ADDENDUM 1

CSP 23-27

GYMNASIUM ADDITIONS/IMPROVEMENTS FOR CAVAZOS & TREVINO ELEMENTARY SCHOOLS

ADDENDUM NO: ONE (1)

A5.2

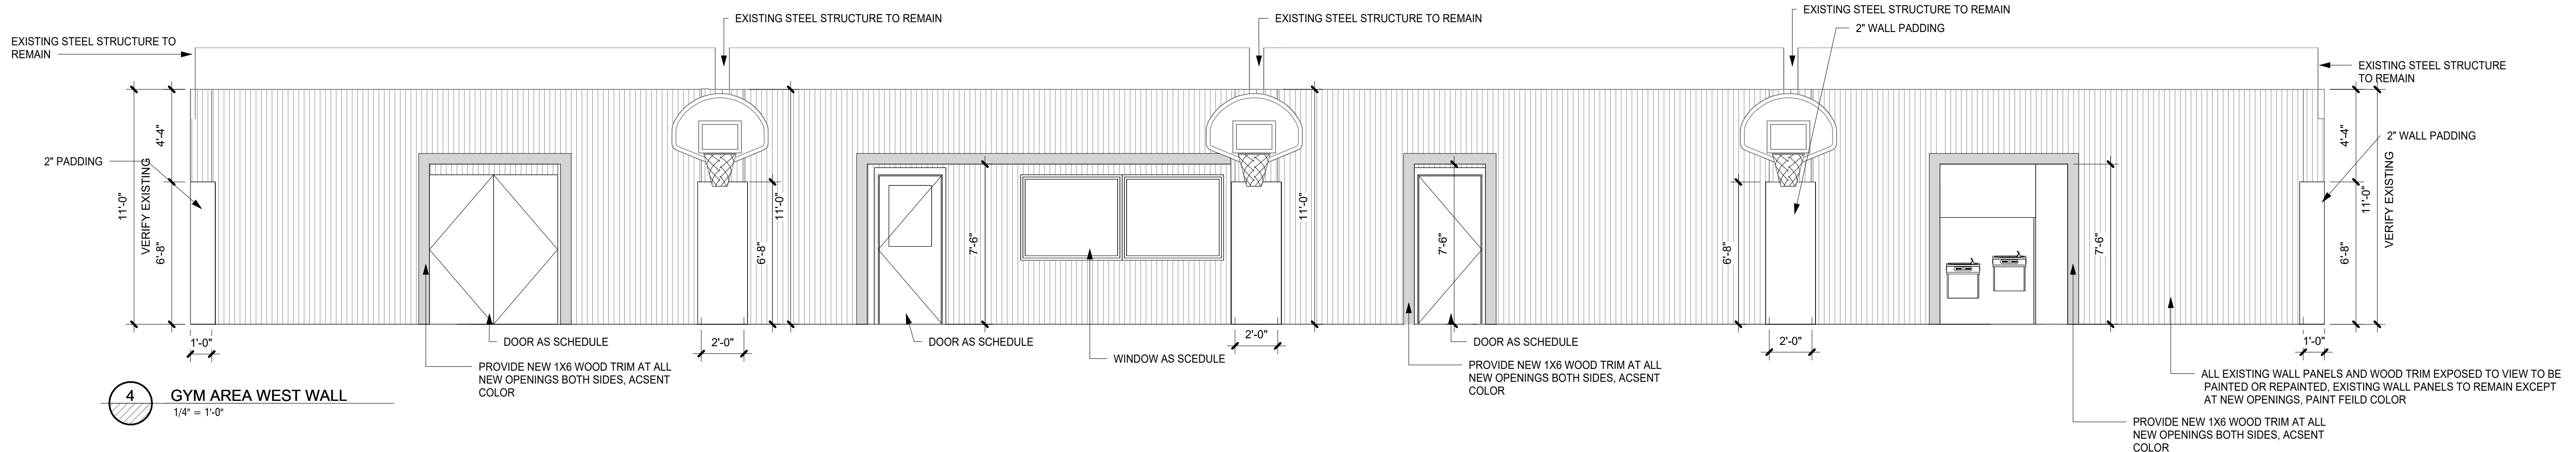
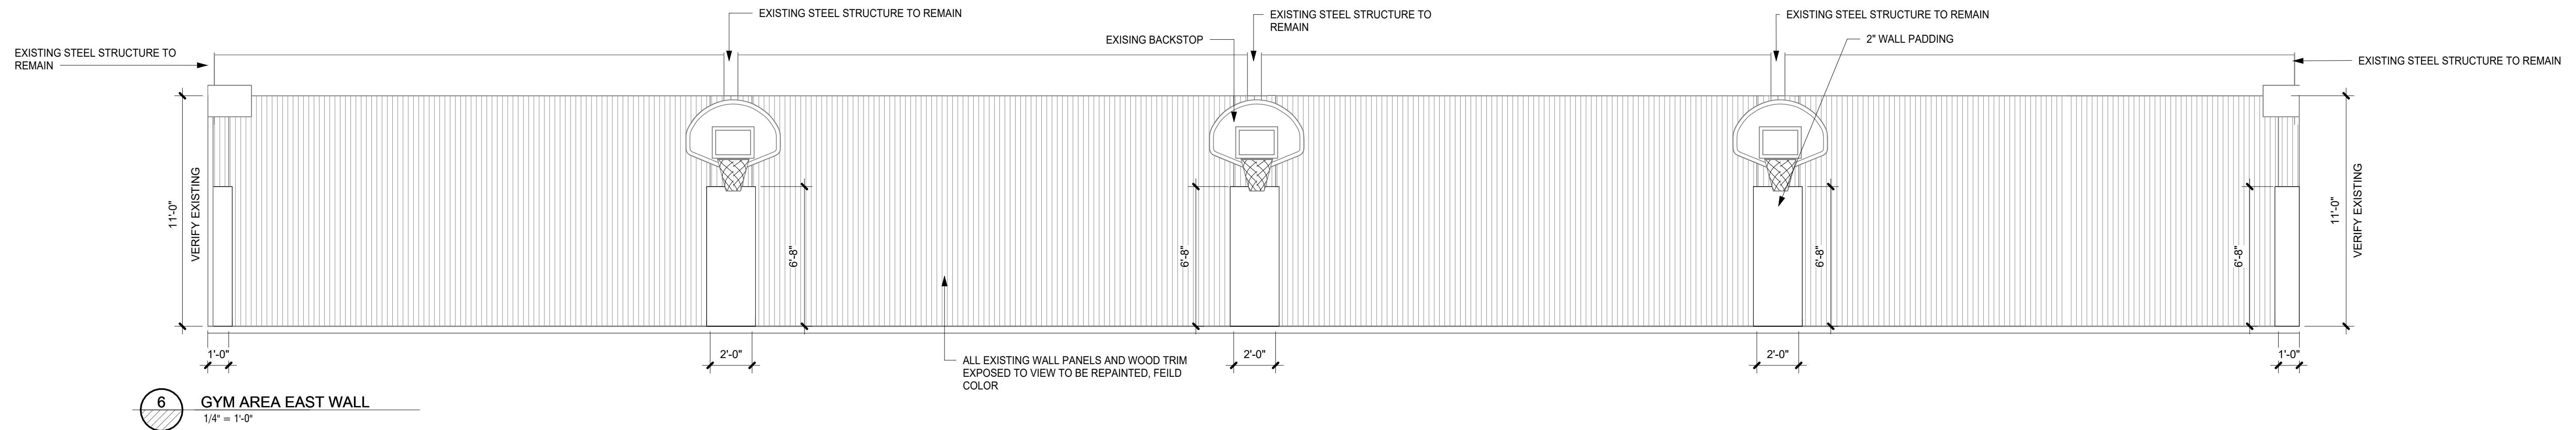
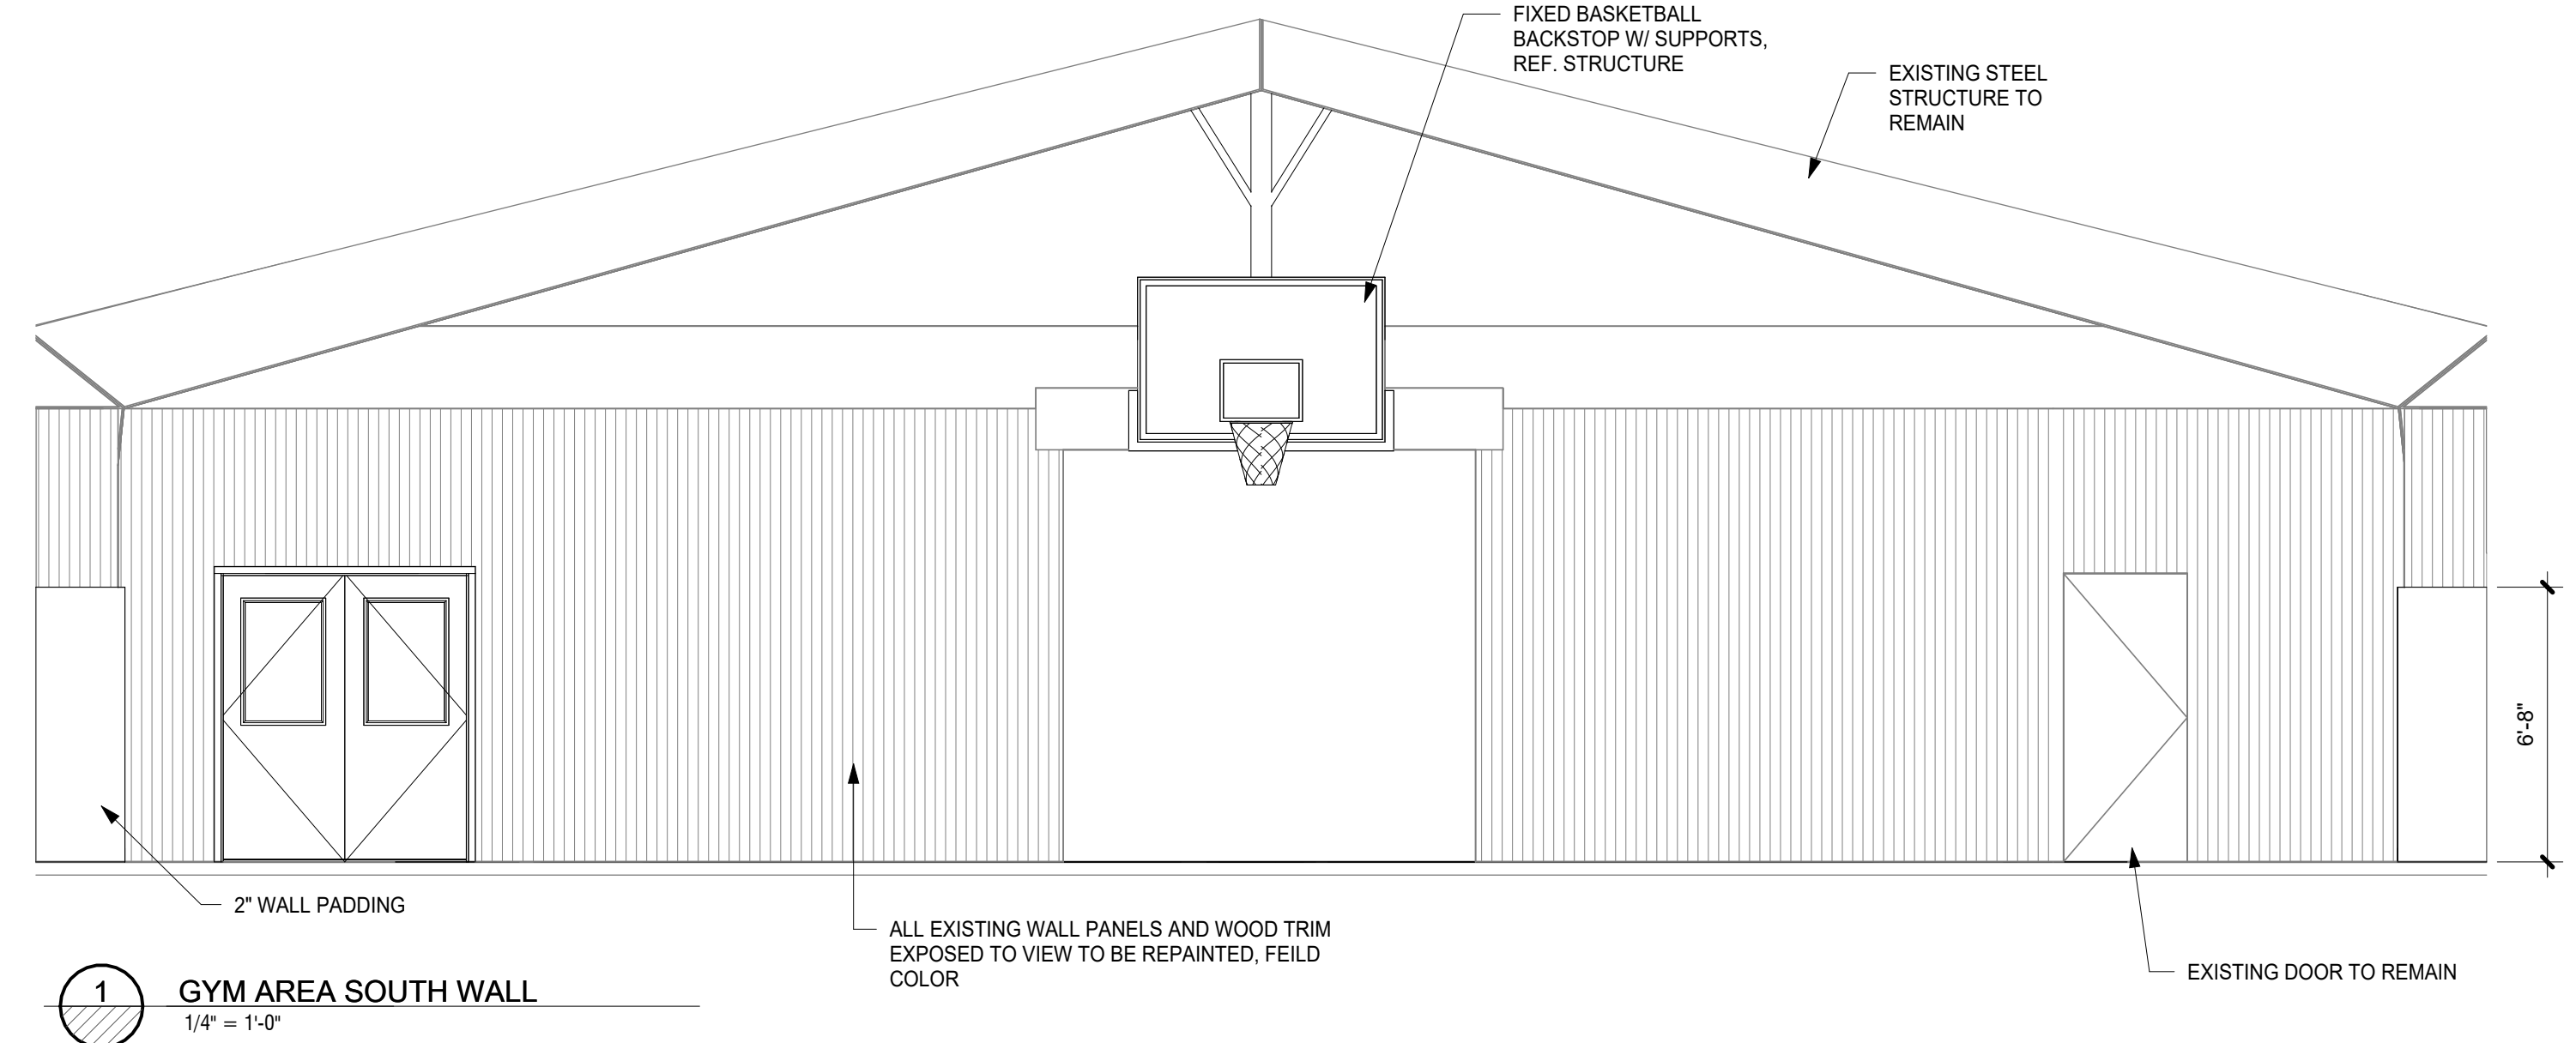
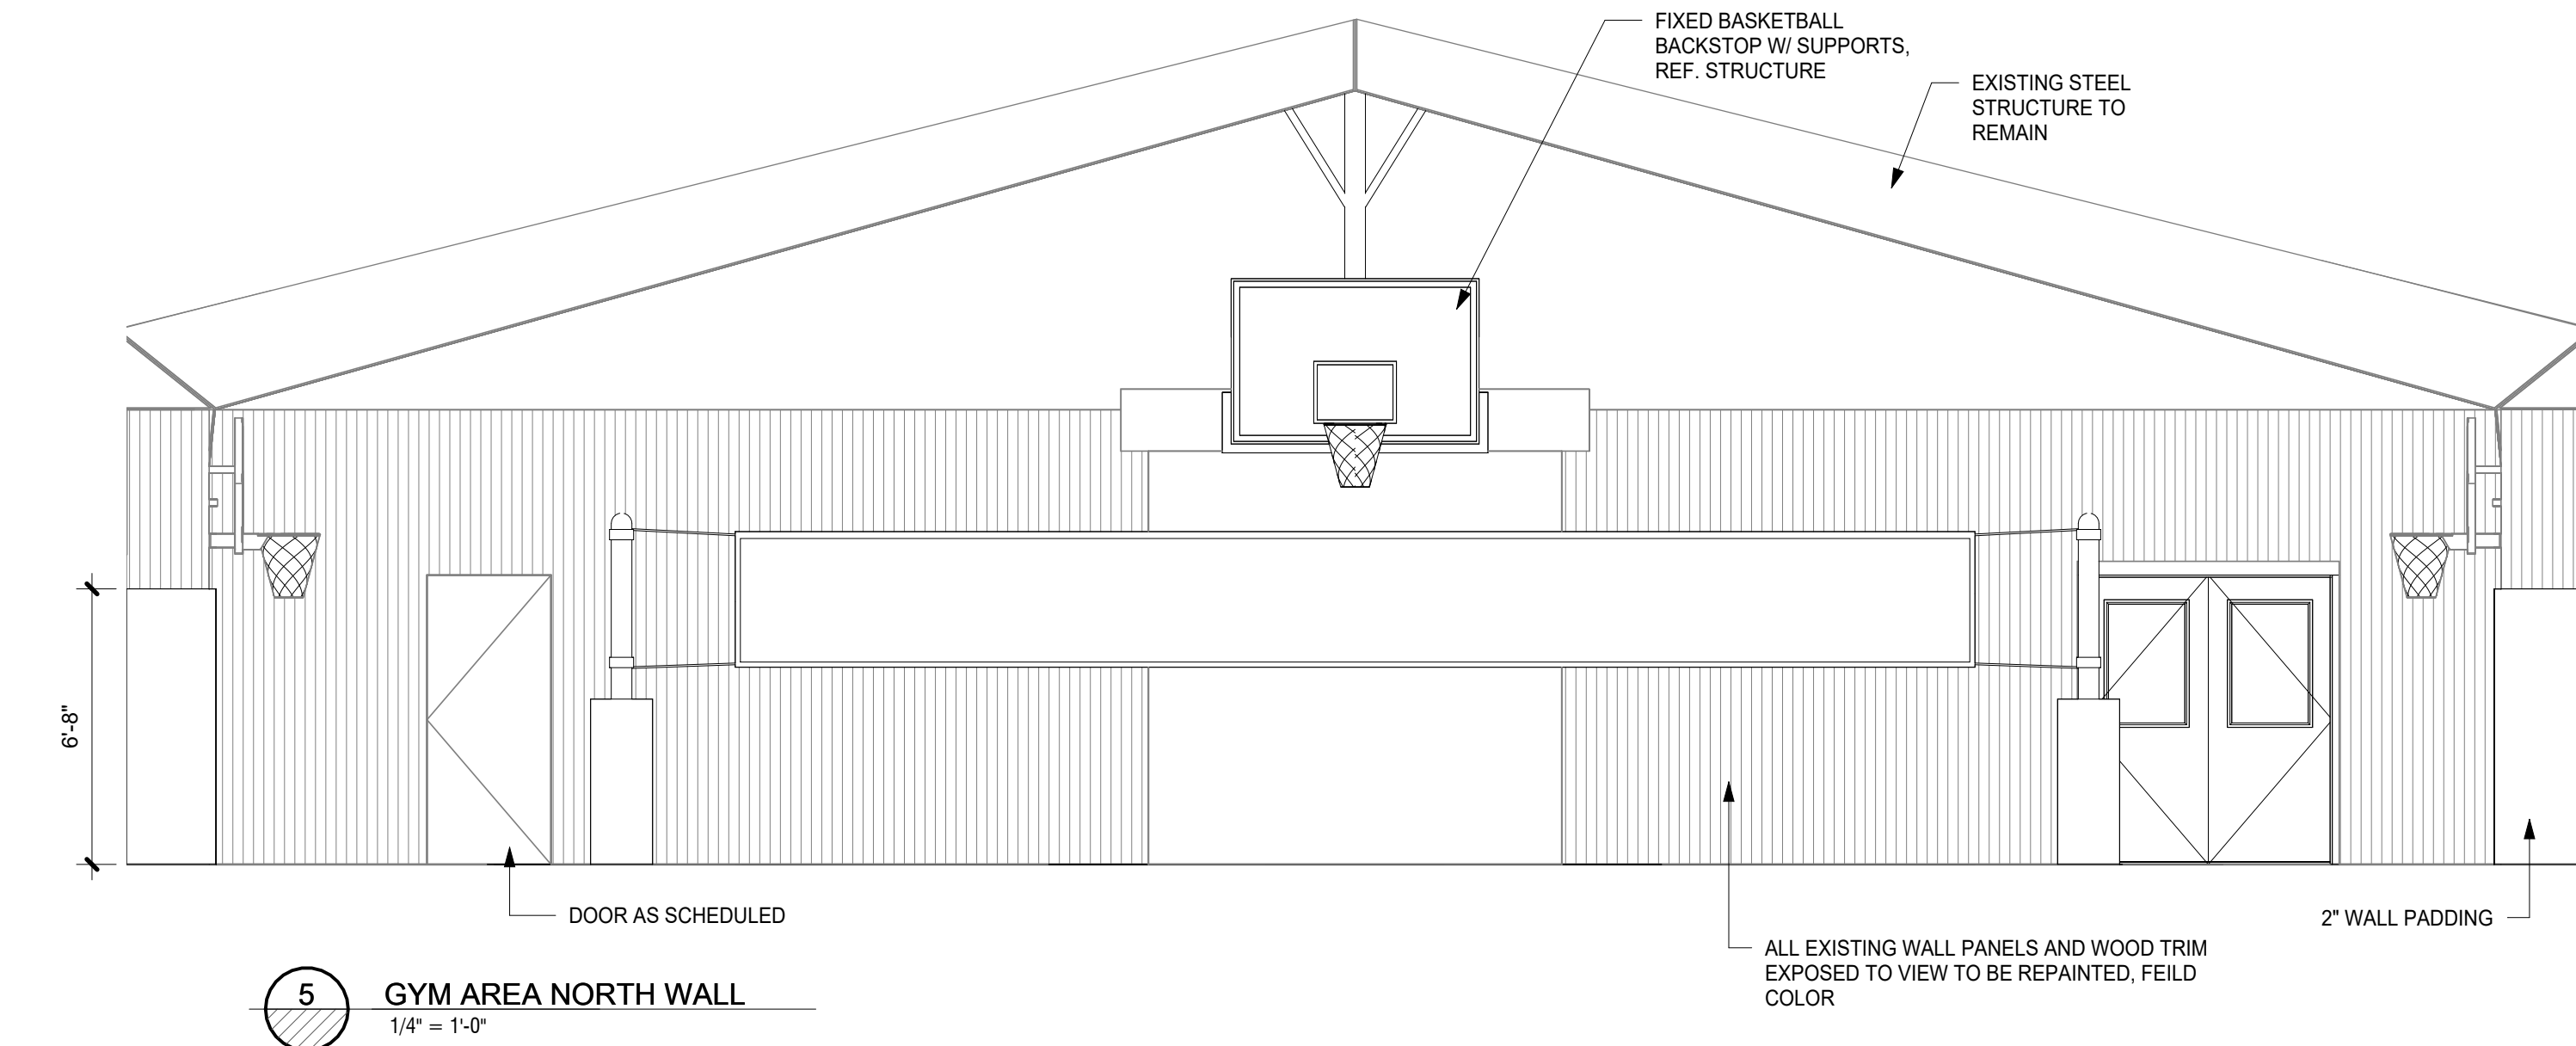
- b. At wall section 4/A4.2 modify wall section as shown and update notes as shown
5. SHEET A5.2 INTERIOR ELEVATIONS (INCLUDED HEREWITH)
 - a. Delete entire sheet A5.2 and replace with sheet A5.2 included herewith

ELECTRICAL PLAN

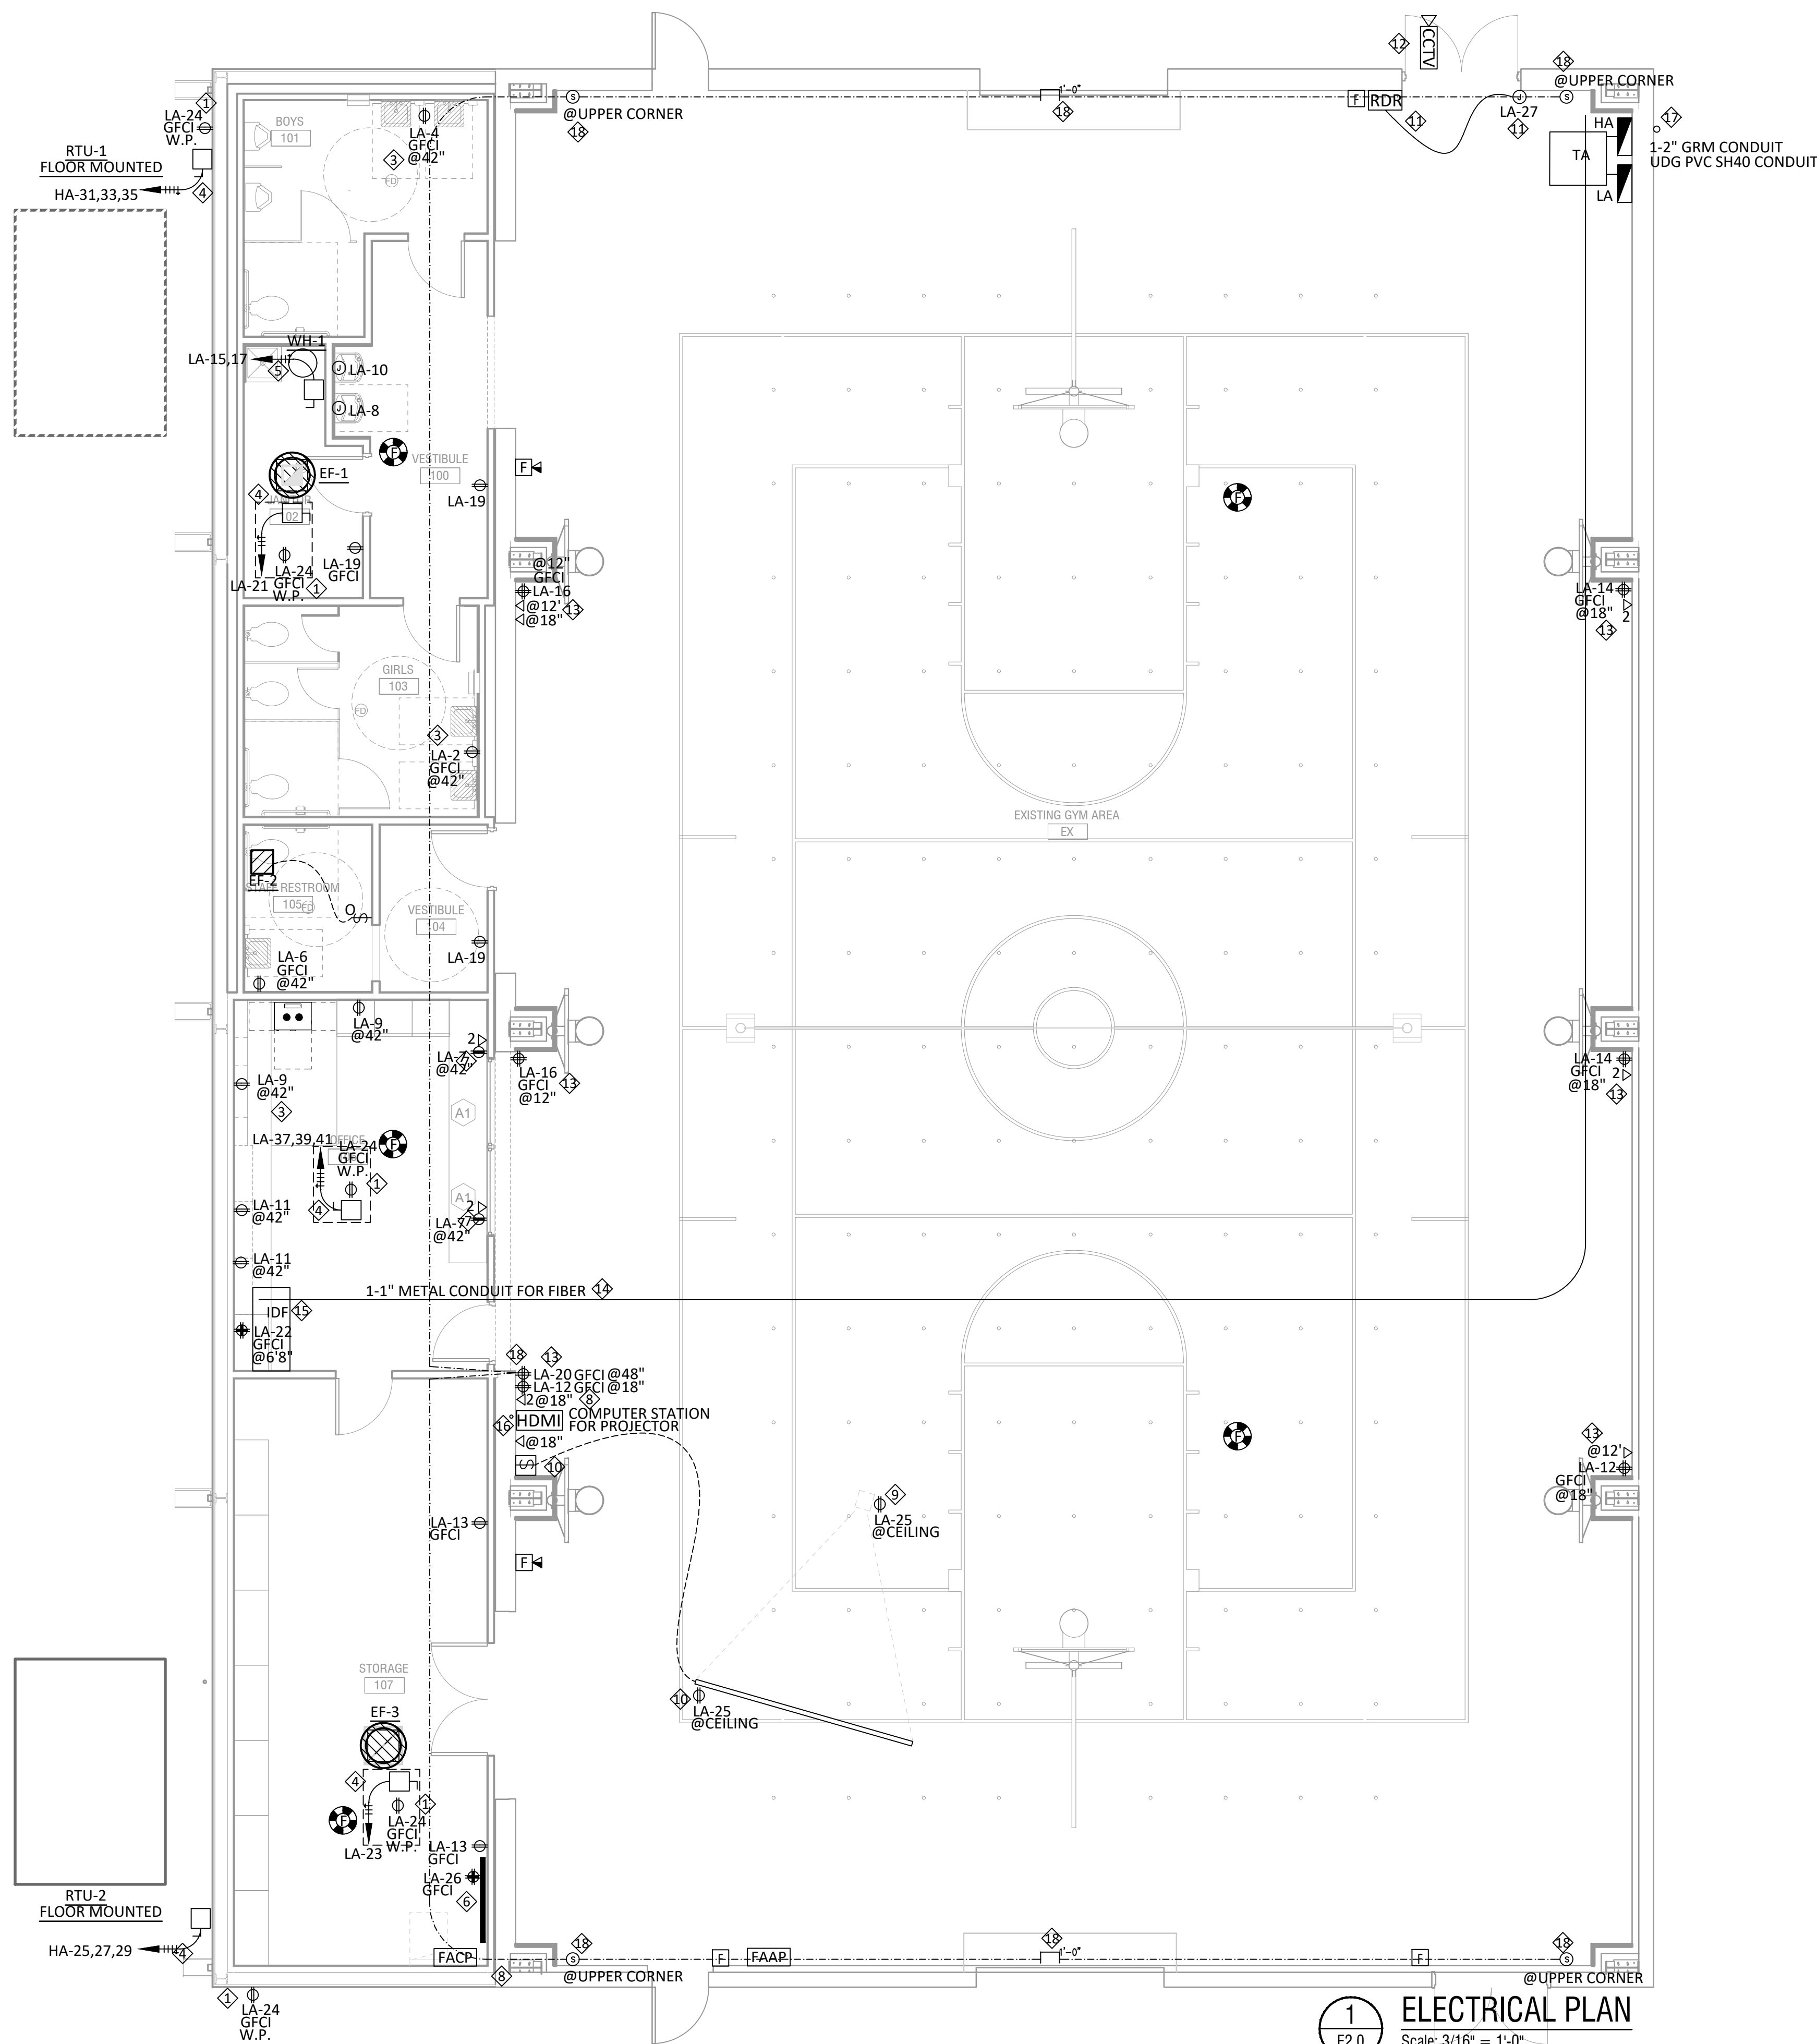
1 – DOOR CLOSURE, SURFACE MOUNTED
7. SHEET E2.0 ELECTRICAL PLAN
 - a. Delete entire sheet E2.0 and replace with sheet E2.0 included herewith
 - b. Added circuit for sound
 - c. Added circuit for IDF
 - d. Added circuit pipe for fiber
8. SHEET E3.0 SCHEDULES AND LOADS I
 - a. Panel LA-add 20A breaker to circuit 20 with 1000 watts load for "RECEPT SOUND"
 - b. Panel LA-add 20A breaker to circuit 22 with 1800 watts load for "RECEPT ISO GND IDF"
